ENGINE - POWER PLANT - INCORPORATION OF MODIFICATION REQUIREMENTS FOR THE E.E.C. AND
IGNITION SUPPLY HARNESS - CATEGORY CODE 4 - MOD.ENG-71-0107

- (1) Aircraft: Airbus A320
- (2) Engine: V2500-A1 Engine prior to Serial No. V0146

V2500-ENG-71-0107

Location of spiral wrapping
Fig.1 (Sheet 1 of 2)

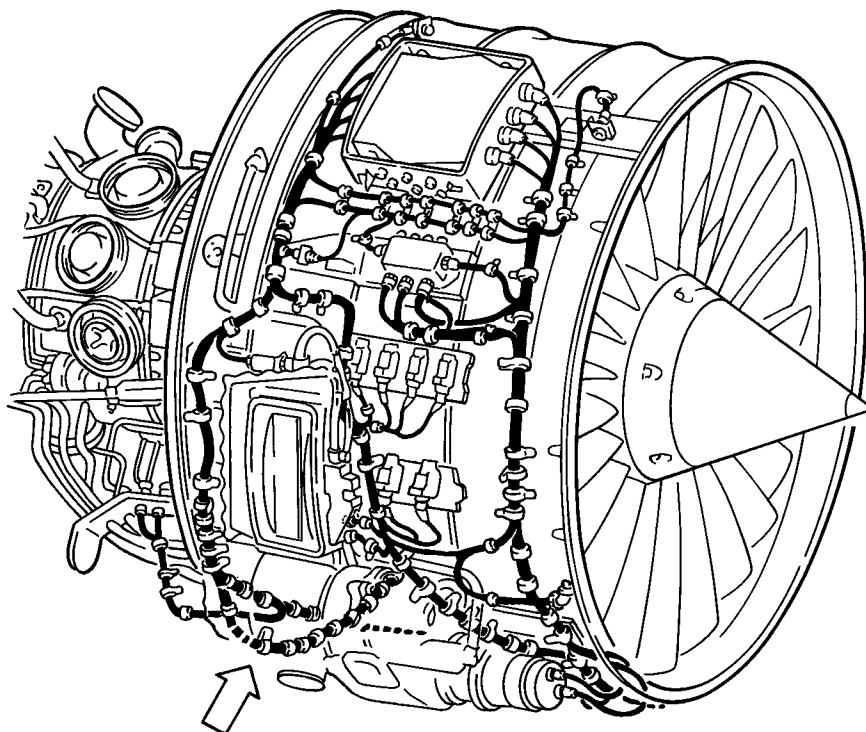
- (1) A continuous length of spiral wrapping is installed on the E.E.C. and double ignition harnesses between clipping points 0544 and 0252 extending to a point midway between clipping points 0252 and 0254. The wrapping is applied to two individual limbs on the E.E.C. harness, one limb feeding connector 4008VC-A and the other feeding connectors 4018KS-A and 4018KS-B. The additional spiral wrapping prevents chafing of the harnesses in this area.

Application of spiratemp wrapping
Fig.3

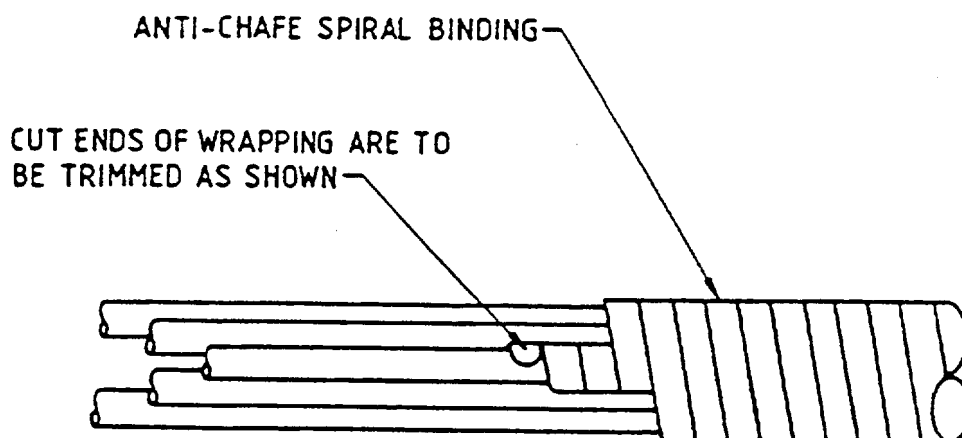
ANTI-CHAFE BINDING TO BE SINGLE WRAPPED AND BUTTED TO FORM CONTINUOUS COVER.

BINDING TO BE SECURED BY PASSING THE END THRU THE BUNDLE AND TAKING TWO TURNS ROUND A SINGLE WIRE AS SHOWN.

SHARP CORNERS OF CUT ENDS TO BE REMOVED.

View on E.E.C. fan harness - Before alteration
Fig.4

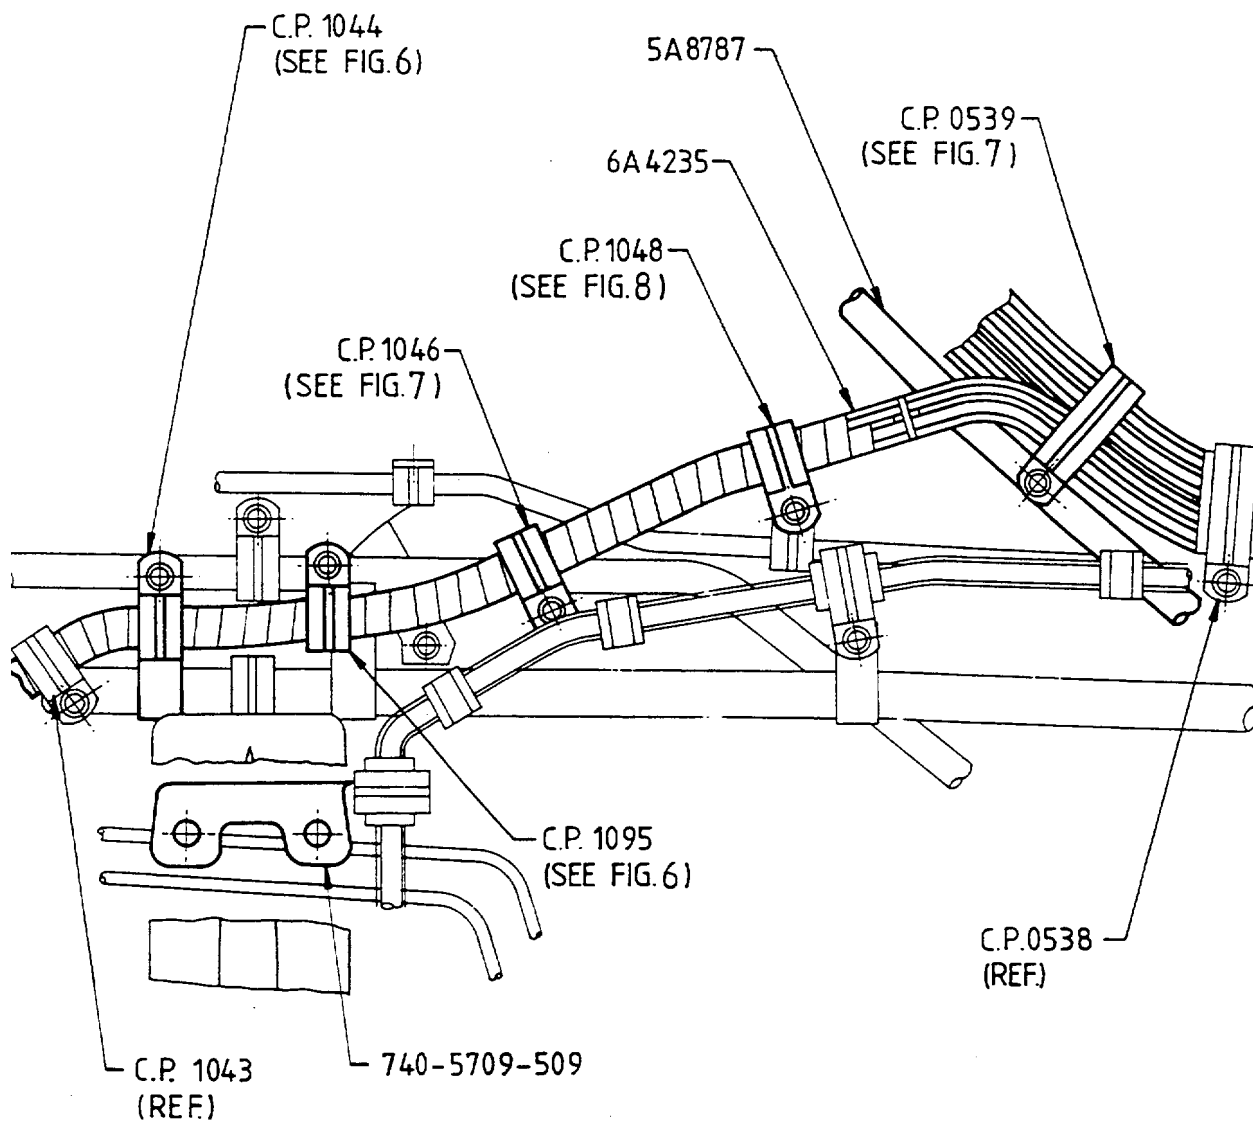
- (2) A re-clipping of the fan harness between clipping points 1043 and 0538 at the bottom of the engine.
- (3) Clipping points 1044, 1095, 1046 and 0539 are deleted as they are no longer required.

View on E.E.C. fan harness - After alteration
Fig.5

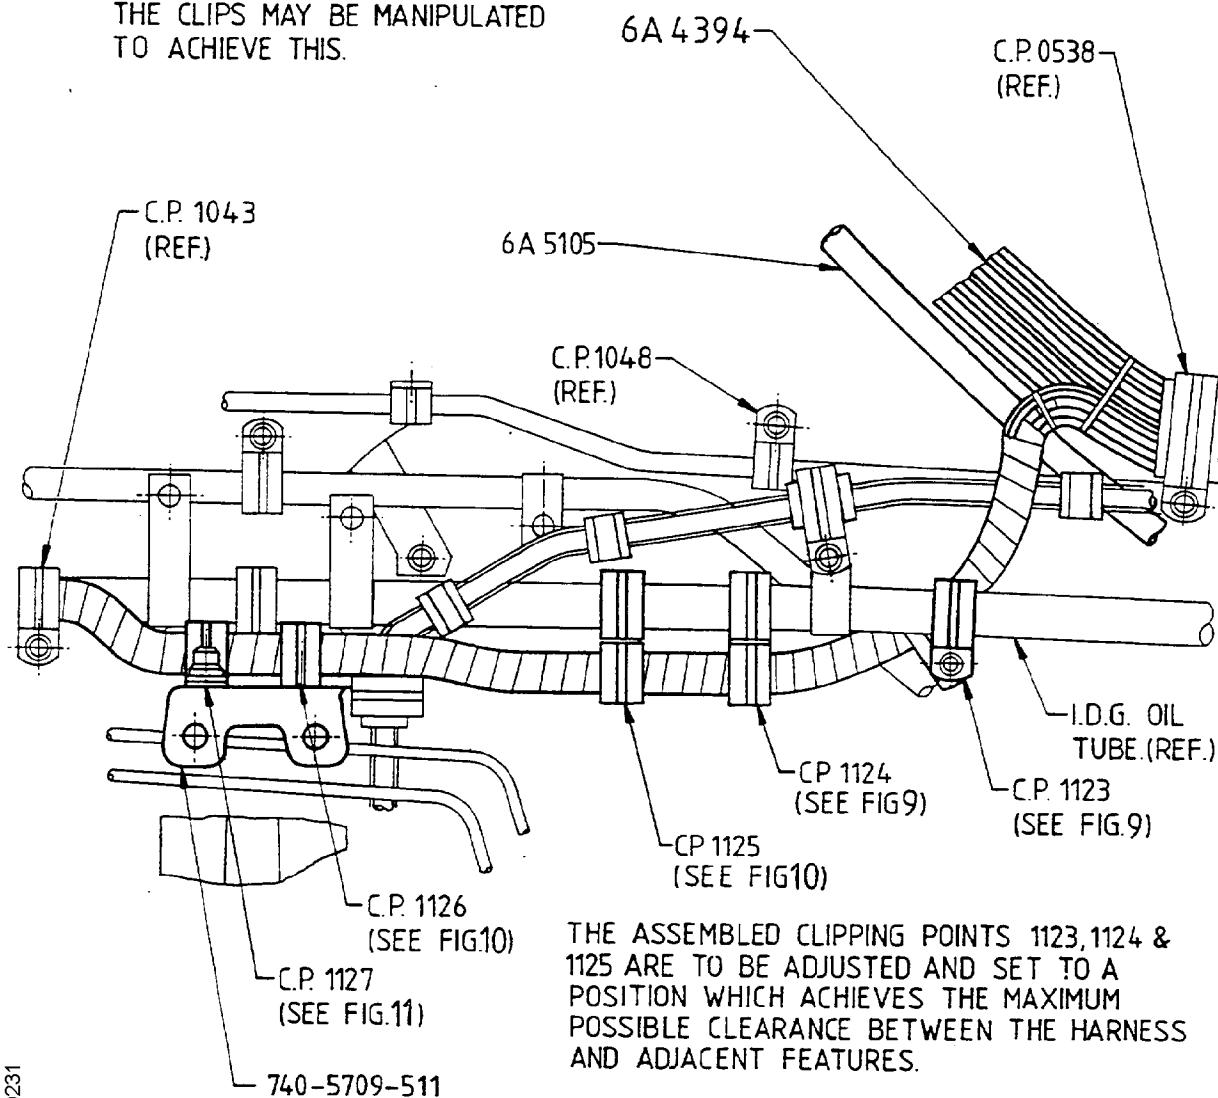
- (4) Clipping point 1048 is amended by deleting the harness clip.
- (5) Five new clipping points have been added, clipping points 1123, 1124 and 1125 are attached to the I.D.G. oil pipe and 1126 and 1127 are bolted to a new drains mast support bracket.

NOTE :- A MINIMUM CLEARANCE OF 0,50mm
(.020in) MUST BE ACHIEVED BETWEEN
THE CLIPS AT C.P. 1126/1127 AND
THE I.D.G. OIL TUBE.
THE CLIPS MAY BE MANIPULATED
TO ACHIEVE THIS.

Clipping point 0539 deleted
Fig.7

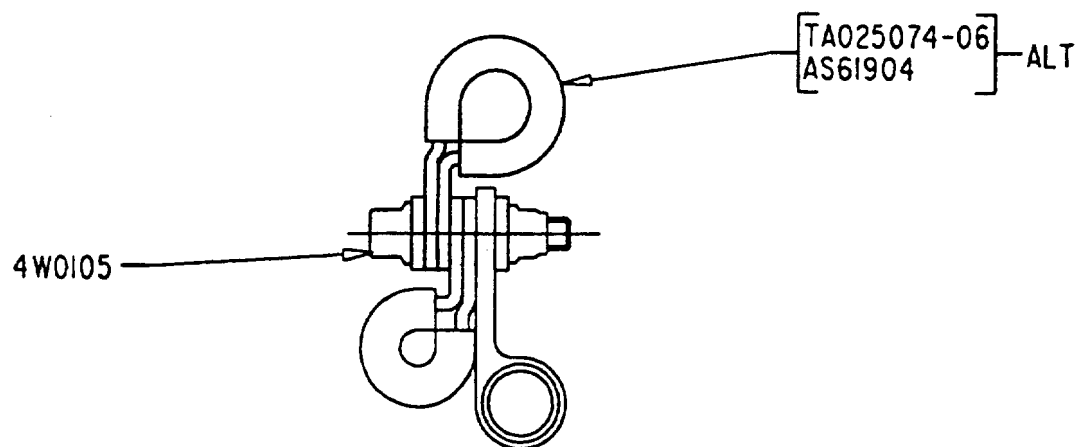
- (6) As clipping point 0539 has been deleted the harness support raceway has been modified with the deletion of a brazed clip at this location.
- (7) Clipping point 0540 has been defined as the new datum position.

Clipping point 1048 - After alteration
Fig.8

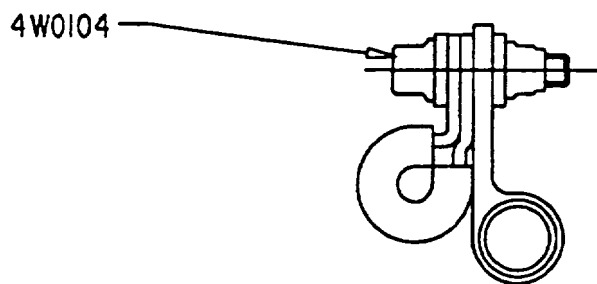
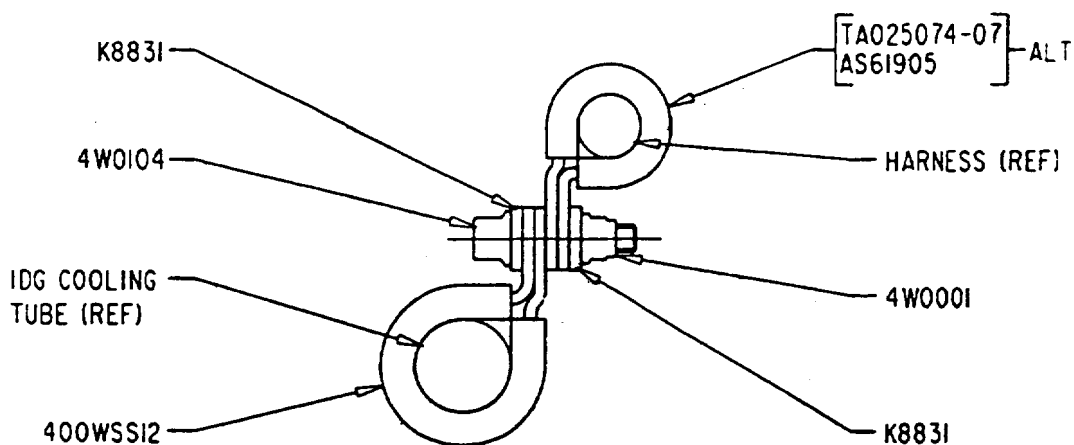
- (8) Deletion of clipping point 1048 for harness assembly 6A4394 requires a new bolt 4W0104 to be fitted at this clipping point, using existing washer K8831 and nut 4W0001 (Refer to Figures 4, 5 and 8), refer to 3. Material Information, for material disposition.

Enlarged section BB showing rework of existing raceway assembly
Fig.19

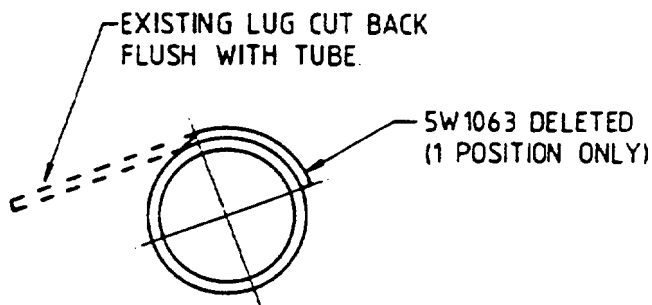
REWORK OF EXISTING RACEWAY ASSY
SHOWING POSITION OF DELETED LUG.

NOTE: CARE MUST BE TAKEN TO
AVOID DAMAGE TO TUBE.

Reworking of existing E.E.C. harnesses showing re-positioned break-out of relay box connector
Fig.20

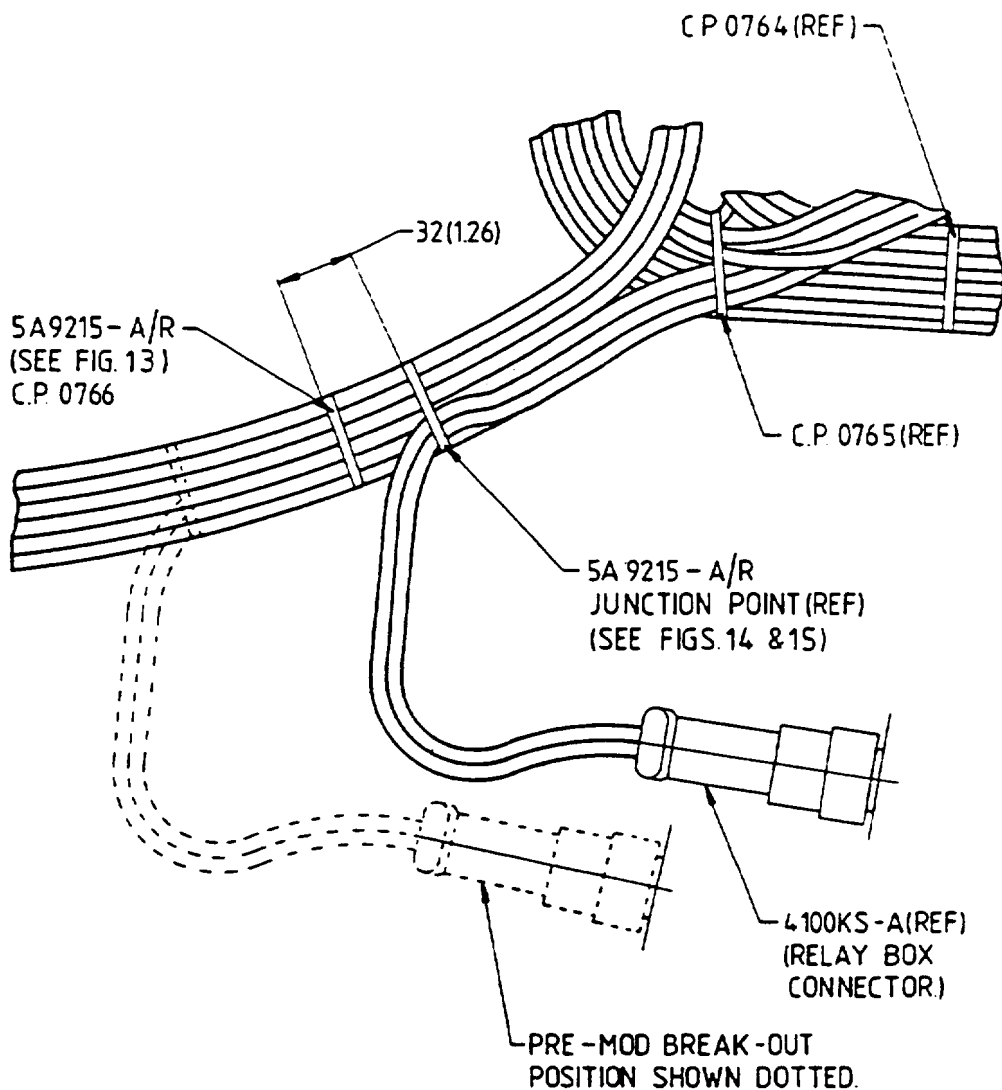
- (8) The existing spiral wrapping anti-chafe sleeving has been extended towards clipping point 0538.
- (9) The limb from the E.E.C. fan harness to the relay box connector 4100KS-A, now "breaks out" before clipping point 0766 i.e. between clipping point 0765 and 0766.

View on end of fuel temperature sensor connector showing repositioning of master keyway relative to the backshell

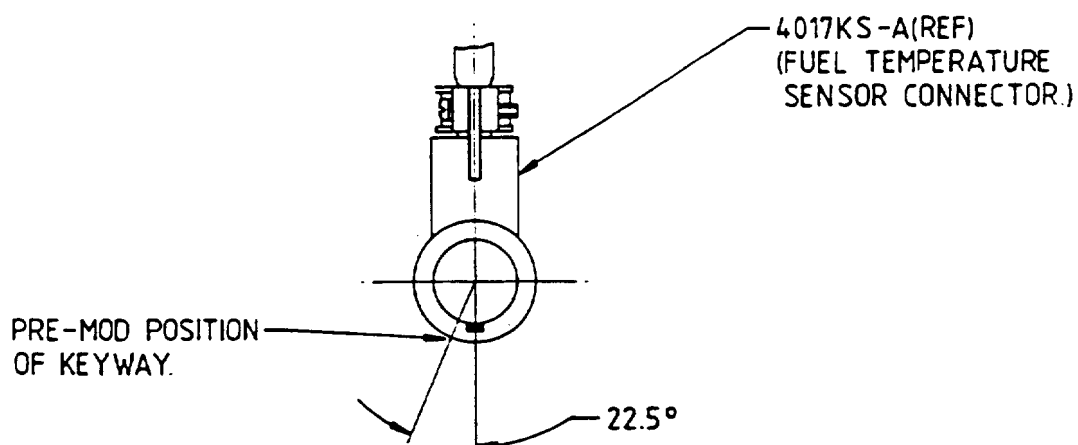
- (10) The 90 deg backshell of the fuel temperature sensor connector 4017KS-A is reorientated towards the fan case by 22.5 deg.

- (a) Fit the fuel temperature thermocouple connection of harness assembly 6A4394 to the fuel temperature sensor.
 - (b) Slacken off the backshell locknut of the thermocouple connection and reposition the connection by 22.5 deg towards the fan case, tighten backshell locknut.

Reworking of existing drains mast support brackets showing enlargement of existing
holes
Fig.22

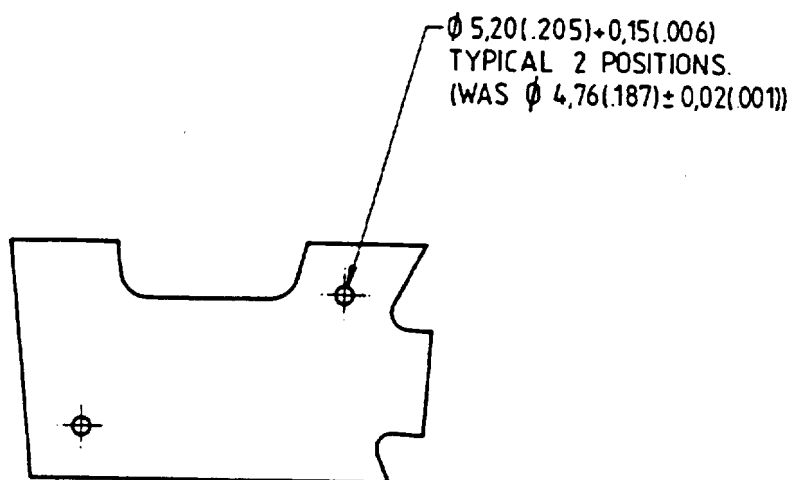
- (a) Drill the two holes to new size See Figure 22.
Use a 5,20 mm (0.205in.) drill and basic workshop tools
- (b) Break sharp edges See Figure 22.
Use basic workshop tools

BREAK SHARP EDGES 0,13(.005) TO 0,25(.010) U.O.S.
